2023MY
Sportage (NQ5, NQ5a)
w/Theta III 2.5L GDI

259

TECHNICAL SERVICE BULLETIN

ITM REPLACEMENT AND ECM
LOGIC IMPROVEMENT (CA2509)

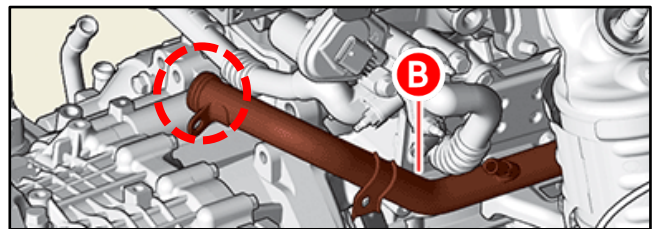
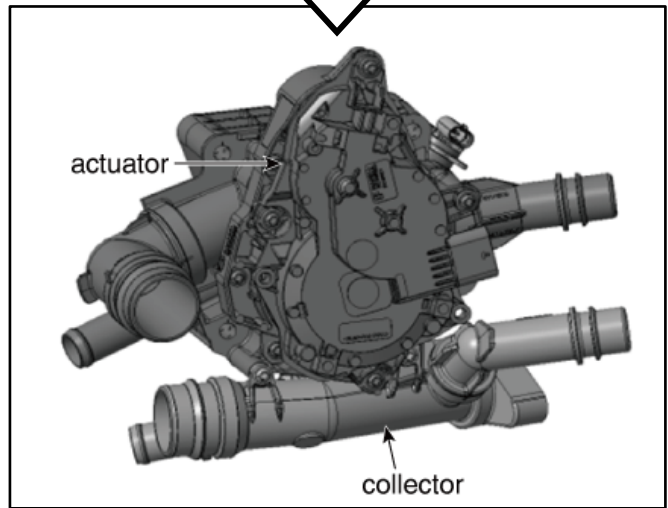
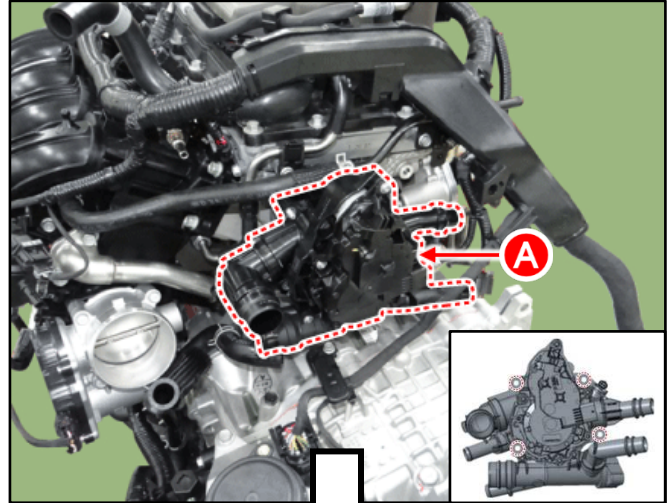
1. Replace the Integrated Thermal Management Module 'ITM' (A) by referring to "Engine Mechanical System → Cooling System → Integrated Thermal Management Module (ITM) → Repair procedures" in the applicable Shop Manual on KGIS.

2. Reinstall all removed parts in reverse order of removal.
3. Install a new inlet pipe (B) O-ring on the red circled area shown.
4. Proceed to upgrade the 'ECM' with Event 854 software in **Manual Mode** only, after ITM part replacement is completed by referring to the ROM ID tables on pages 3-5.
5. Verify normal vehicle operation.

Tightening torque for bolts:
7.2 - 8.7 lb.ft (9.8 - 11.8 N.m)

Do NOT disassemble the actuator and collector. The new ITM is supplied as an assembly unit.

UPGRADE EVENT:

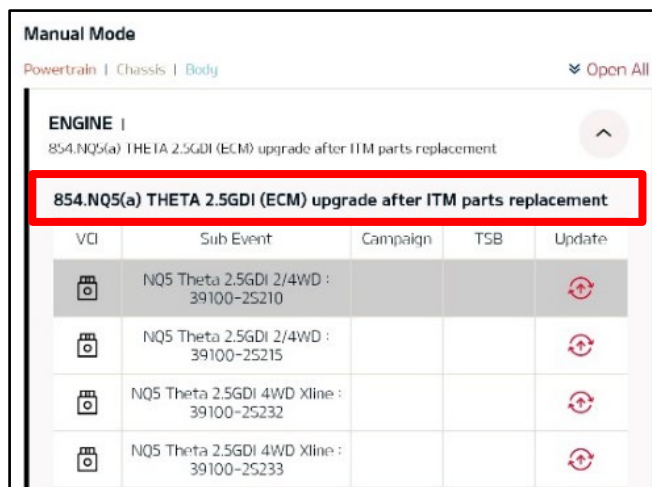
Select the applicable **'ECM'** system module and the Event Group.

- 854.NQ5(a) THETA 2.5GDI (ECM) Upgrade After ITM Parts Replacement
